Architects Supplemental Instruction (ASI)

Project: West Birch Apartments and Townhomes	ASI #: 01
Owner: West Birch Estates of Princeton	Date of Issuance: 09/26/19
To: Lumber One Avon	Architect's project #: 616-18

The intent of this ASI is to amend the Project Documents to incorporate various VE items which were unintentionally omitted in previous document revisions. It is not expected that any of the included items will have any impact on current Project Pricing.

2 WINDOW HEAD & SILL DETAIL @ STUD (SECTION VIEW)

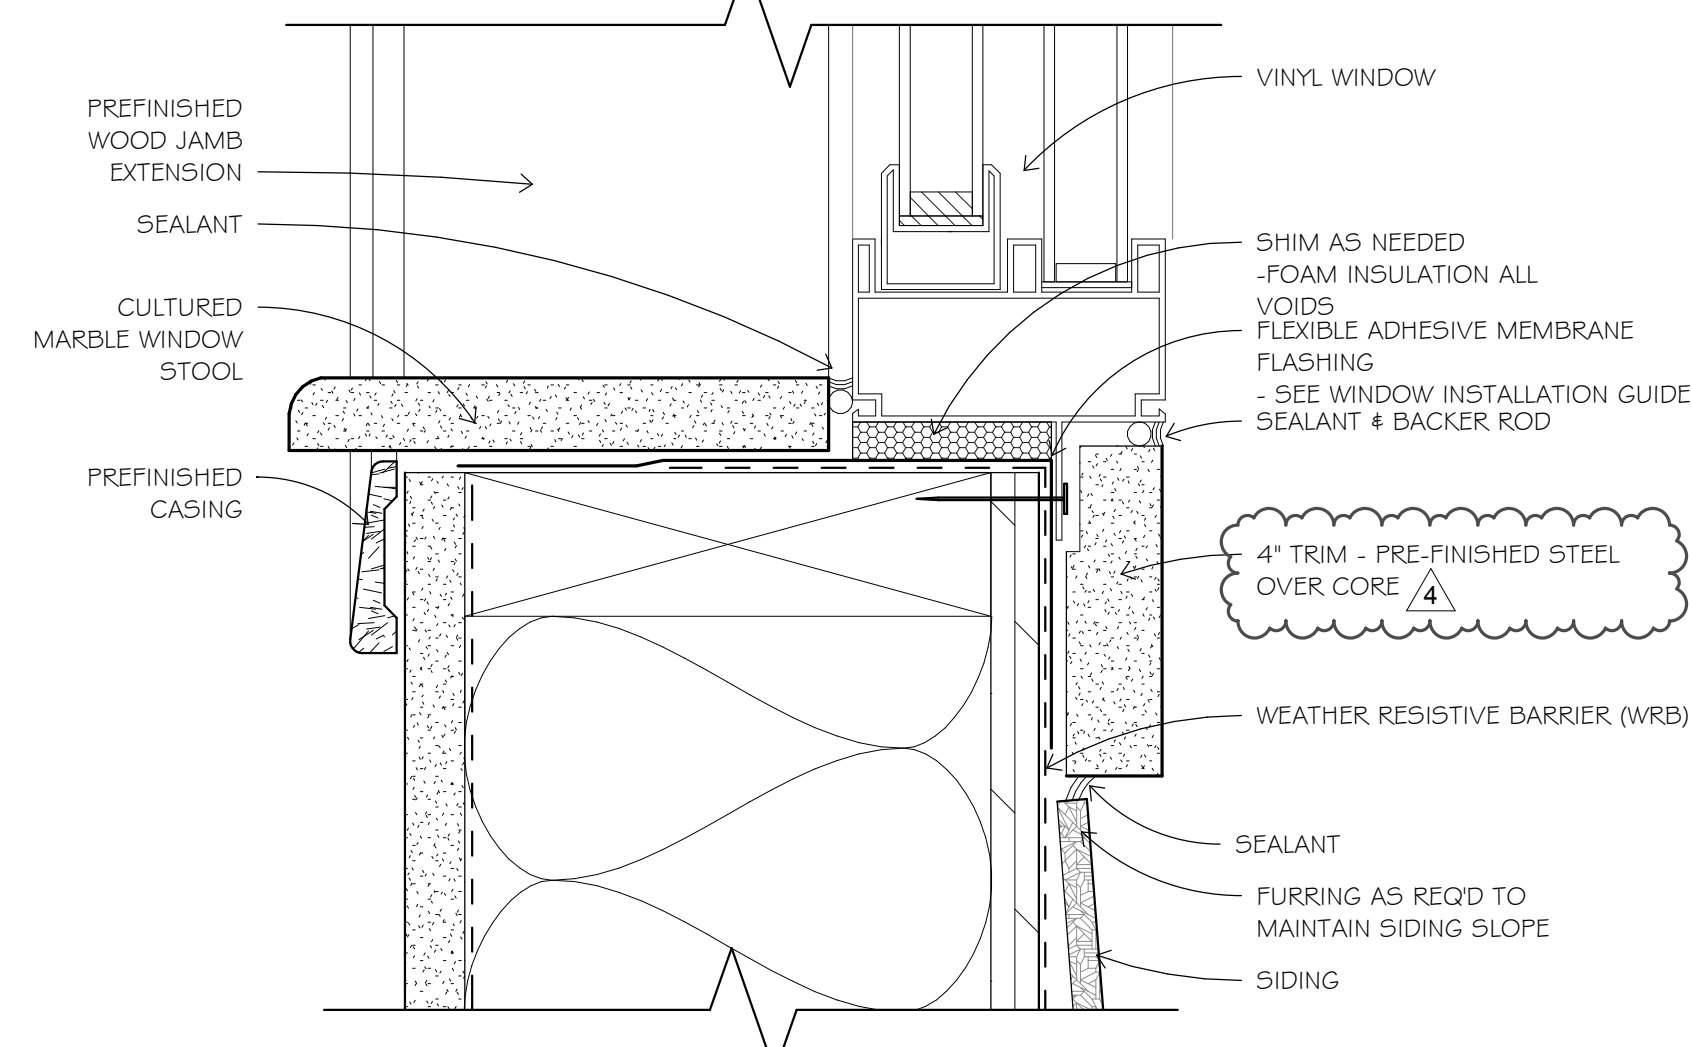
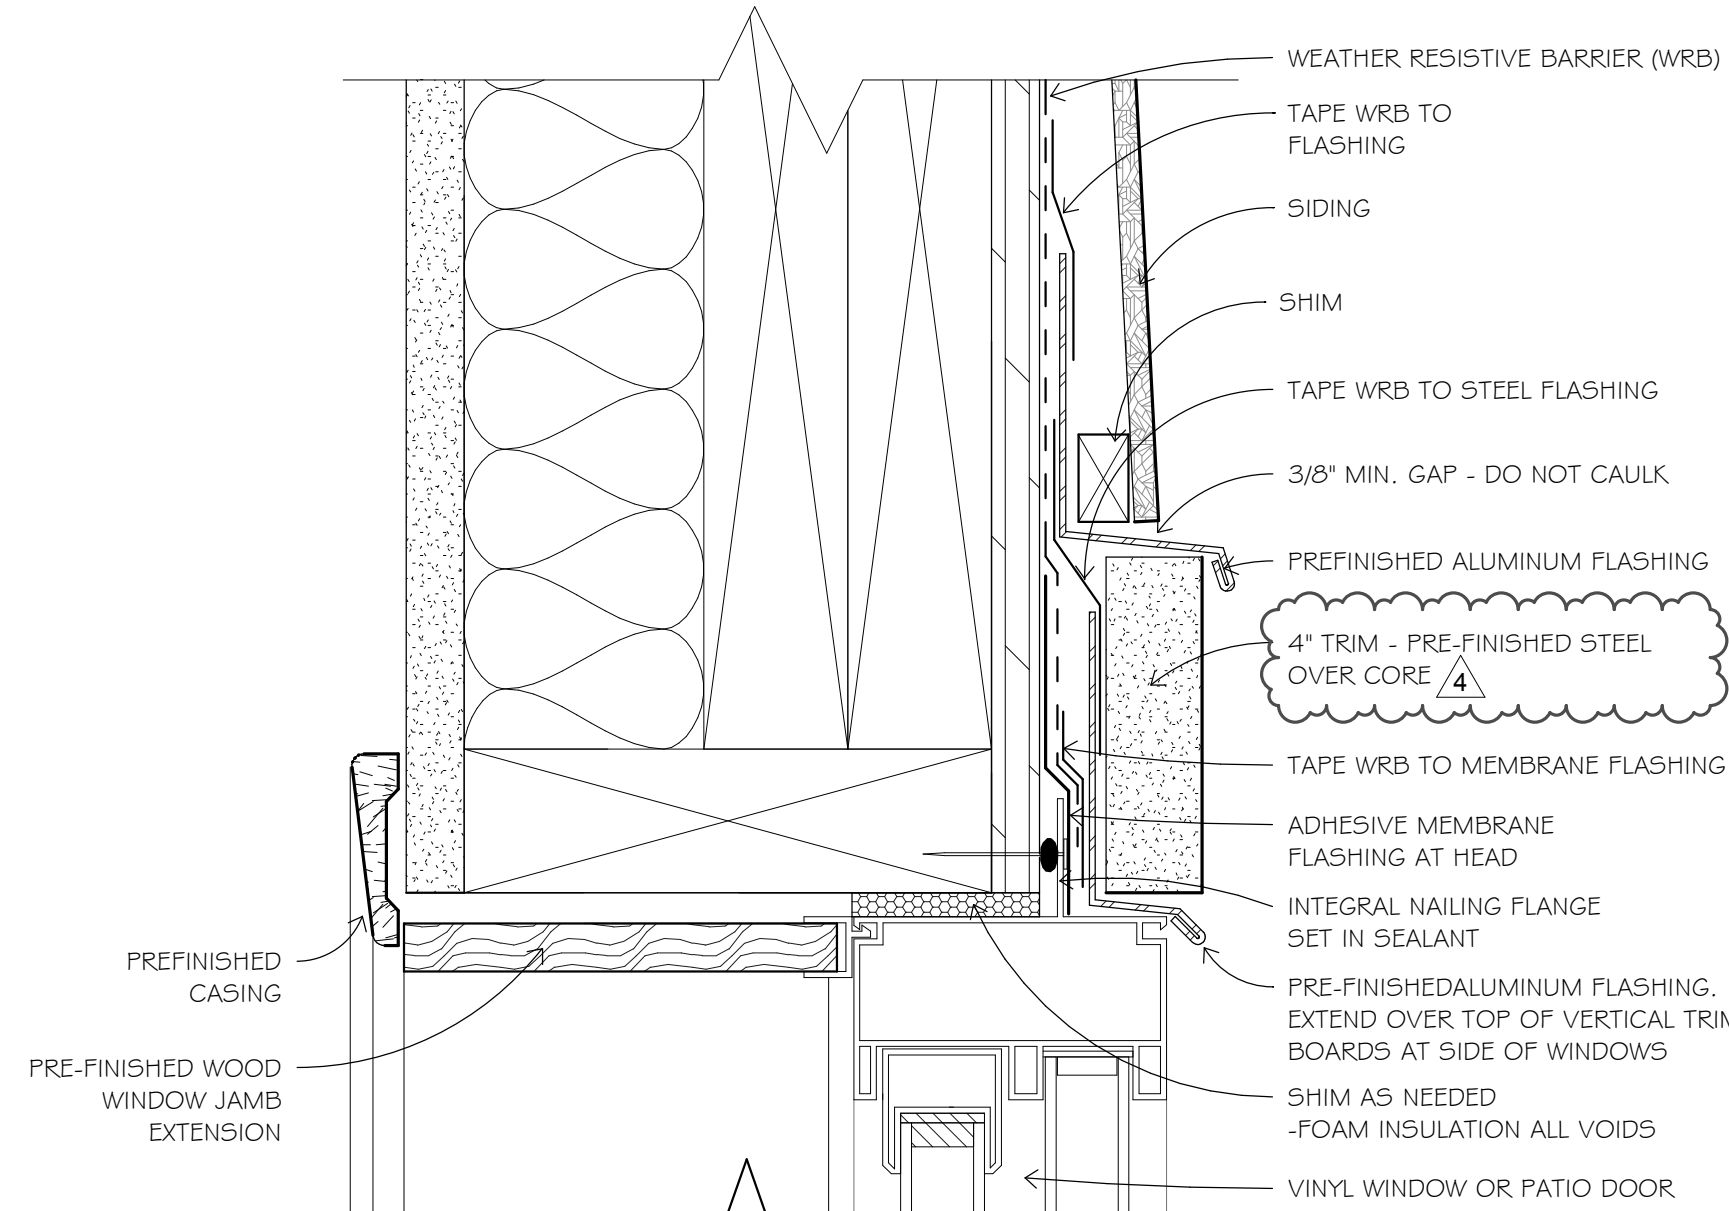
1. Removed text notes referring to cellular PVC trim and replaced them with text notes referring to steel clad trim. Refer to the following sheets (Attached):
 - a. Sheet A310 – Wall Section – detail 2/A310
 - b. Sheet A602 – Exterior Details – Detail 3/A602
 - c. Sheet A603 – Exterior Details at Openings – 2/A603, 4/603
2. Removed medicine cabinets. Refer to the following sheets (Attached):
 - a. Sheet A410 – Enlarged Plans – Unit Types A, A.1, B, & F - Detail 1/A410, 2/A410, 3/A410
 - b. Sheet A411 - Enlarged Plans – Unit Types C, C.1 & D – 1/A411, 2/A411
 - c. Sheet A412 - Enlarged Plans – Unit Types E (ACC) & C.2 (ACC) – 2/A412, 4/A412

1 SECOND FLOOR FRAMING PLAN
S112 1/8" = 1'-0"

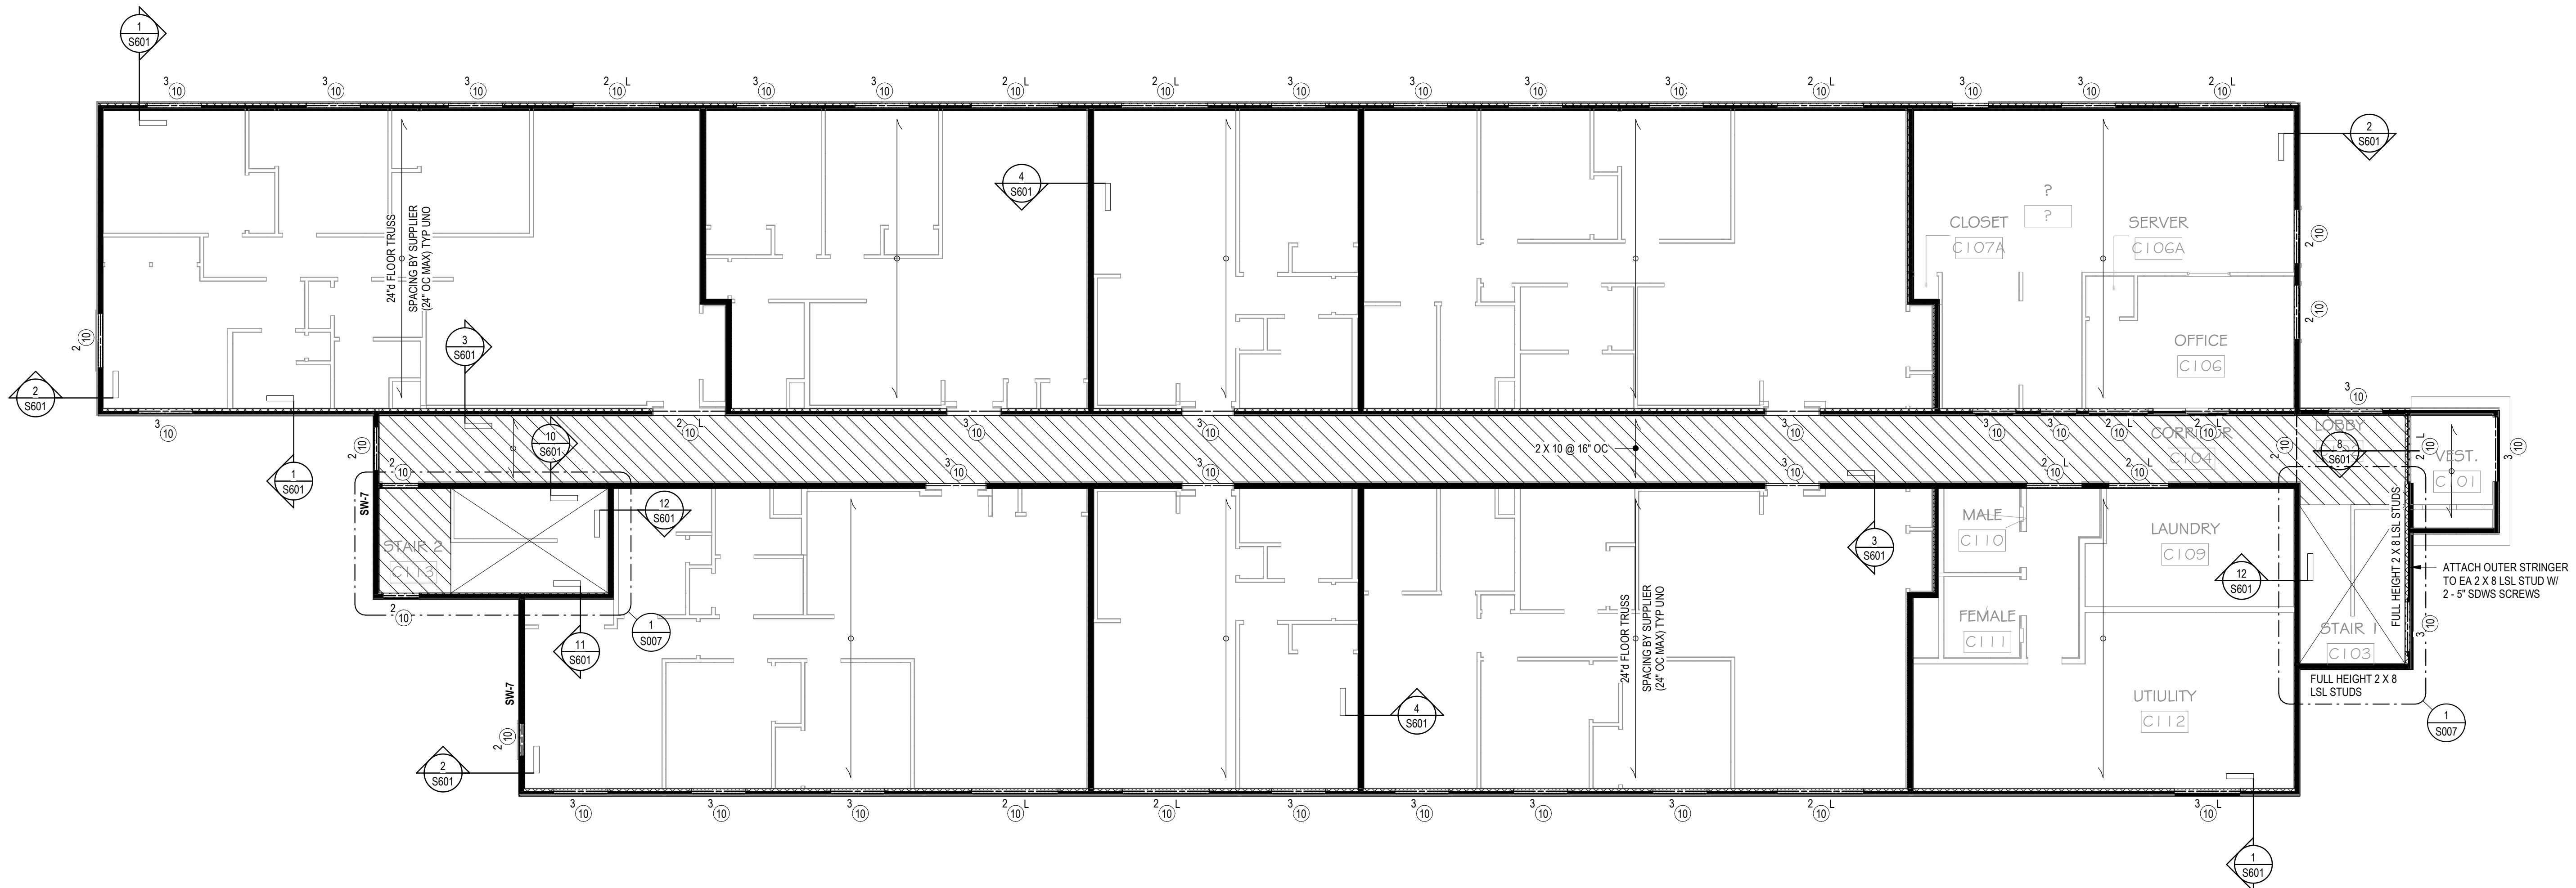
3. Sheet S112 (Attached):

- a. Revised note C.3. to provide 15/32" roof sheathing ILO previously indicated 5/8" roof sheathing.

- 1. See Architectural for top of sheathing elevations.
- 2. Floor sheathing shall be 3/4" APA rated plywood / OSB. Attach sheathing to floor framing members with 10d nails (0.128" diameter x 3" long) at 6" OC at panel edges and 12" OC at intermediate supports.
- 3. Roof sheathing shall be 15/32" OSB sheathing. Attach sheathing to roof framing members with 10d nails (0.128" diameter x 3" long) at 6" OC at panel edges and 12" OC at intermediate supports.
- 4. All diaphragm nailing shall be done with common nails and shall be driven flush but not fracture the surface of the sheathing. Box or sinker nails must be approved prior to use.
- 5. As an alternate to hand nailing the contractor shall submit for approval the size and type of nail used for automatic nailing with the approved technical data for its use in nailing horizontal diaphragms.
